THE UNIVERSITY OF TEXAS AT AUSTIN

Nuclear Engineering Teaching Laboratory · <http://www.me.utexas.edu/~nuclear/index.php/neitl>
1 University Station, R9000 · Austin, Texas · 78712 · (512) 232-5370 · Fax (512) 471-4589

Subject: Request for Change to License Technical Specifications Incorporating 2008,
2010, and 2011 Requests

Appendix A
DRAFT Technical Specifications
Revision 2
Docket 50-602
The University of Texas at Austin
TRIGA Reactor
JUNE 2012

Figure A.3.1.1-1, Xenon Concentration Following Shutdown (Linear Scale)

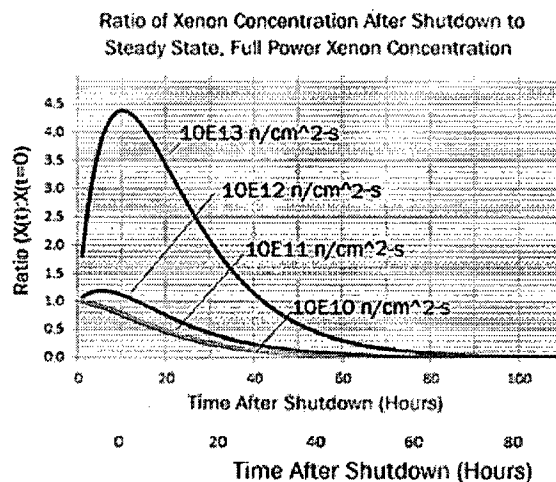
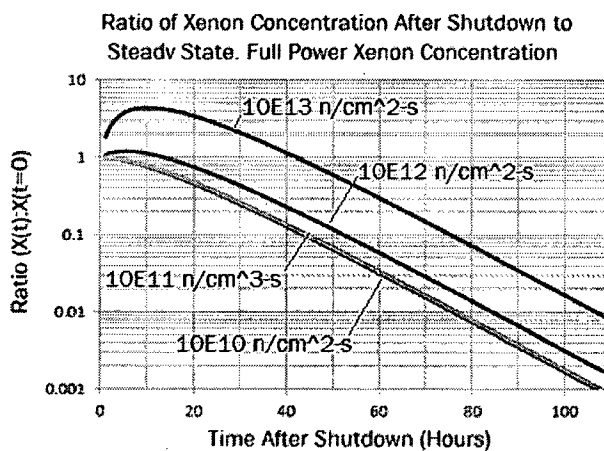
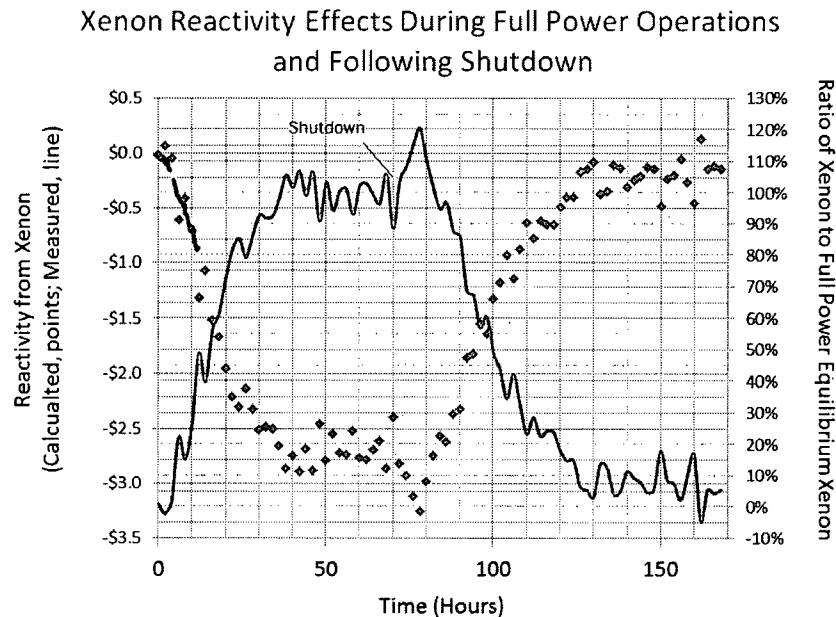
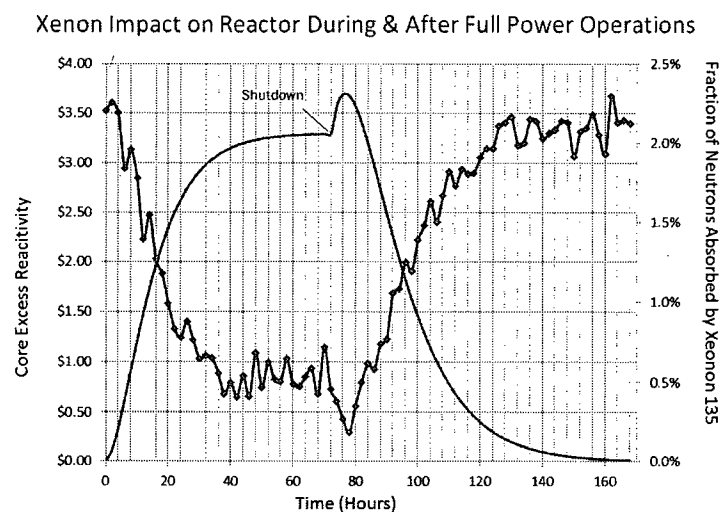
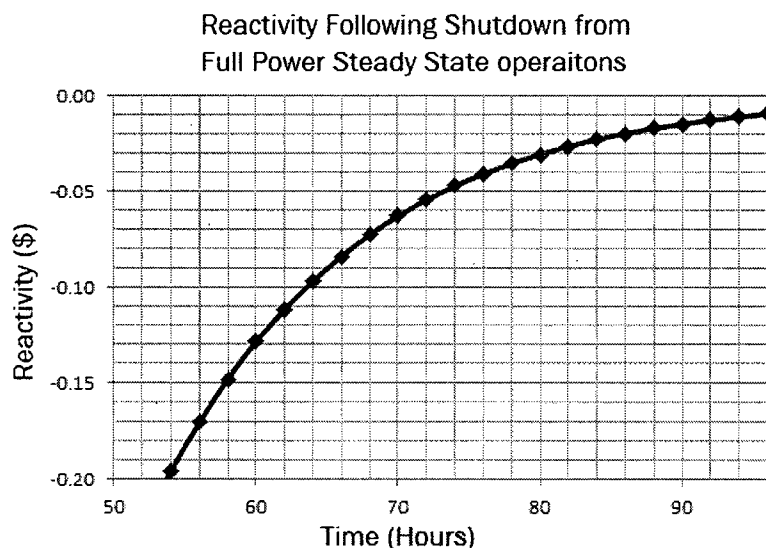
Response to RAI 5.b: The *reference core conditions* are used to verify reactivity limits are met. An accurate assessment of reactivity in the reference core conditions is significant. The original definition for reference core condition was taken from ANSI 15.1, and includes a considerable margin of error. However, the UT facility has never determined reference core conditions with significant xenon present, and does not consider a reference reactivity value with a large margin of error useful or desirable.

Calculations show that reactivity change from xenon following shutdown from full power equilibrium conditions cannot be detected using control rod positions after 72 hours, where the reactivity from xenon is less than the β_{eff} (which experience shows is a minimum detectable level based on a single control rod differential position). Therefore, a more conservative approach is proposed where the reference core condition is restricted to conditions where reactivity from xenon is below the level that would occur 72 hours after shutdown. This may be verified in determining the reference core condition by allowing a 72 shutdown hour interval or by calculation when desired (for instance, when the reactor has not achieved equilibrium conditions prior to shutdown).

The specification has been revised to reflect this proposed requirement, and supporting analysis has been completed and incorporated in a revision to the basis for section 3.1.

- A.3.1 – Analysis of xenon transients to justify limits on reactivity from xenon when determining reference core conditions.
- A.3.1.2 – Incorporation of the restriction on using experiments to credit shutdown margin.
